City of Mississauga Department Comments

Date Finalized: 2022-03-02 File(s): A102.22

Property Address: 729 Byngmount Avenue

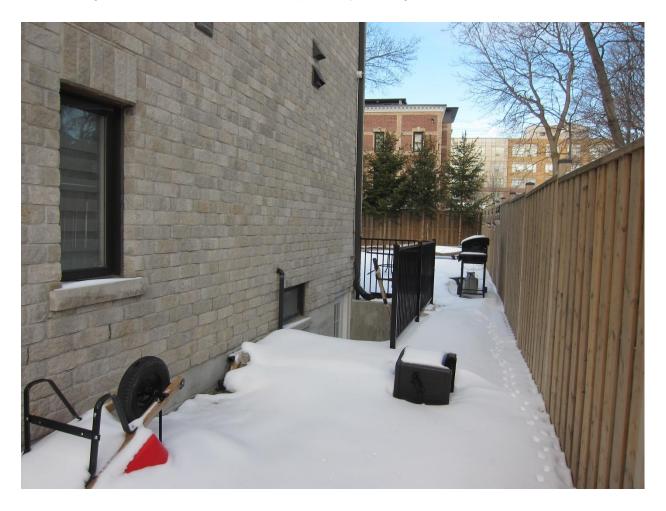
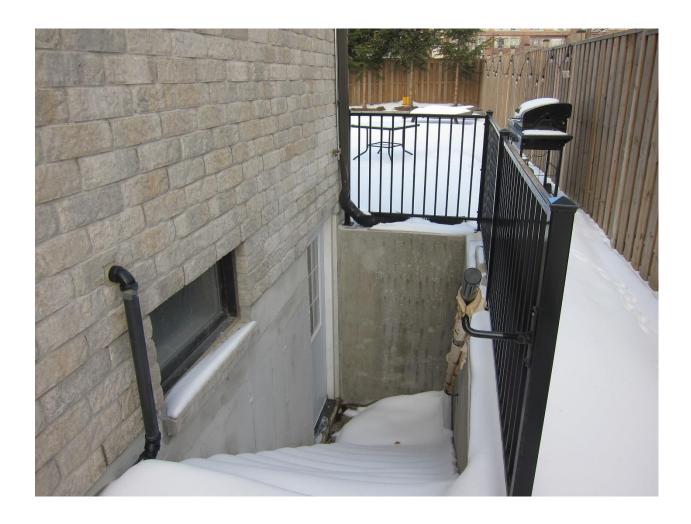
Enclosed for Committees information are photos depicting the existing below grade entrance. The existing entrance does not seem to impose any drainage concerns.
